# DSO9064A-03

## S E R V I C E N O T E

### DSO9064A Oscilloscope: 600MHz, 4 analog channels

Serial Numbers: MY0000001-MY52250100, SG00000001-SG52250100

Figure #1.

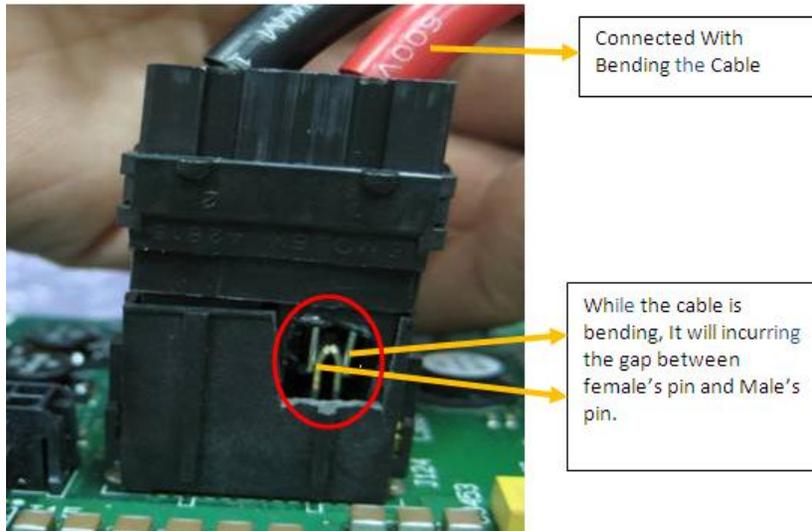
Many customers are experiencing Random Shutdowns. This make them want to have Service Note - 02A completed. The problem is with service note -02A, this isn't the only possible cause for the symptom consequently not resolving their problems. This issue has been determined to be a connection problem with the J124 connector on the acquisition assembly and the 12 volt power cable. See figure #1.

Replace the 12 Volt Bulk power cable to the longer version 54904-61631 eliminating the connector tilt increasing the surface tension. See Figure #2. Clean and inspect the connection J124 on the acquisition board. If the J124 is pitted then replace the acquisition board. Use contact cleaner or alcohol.
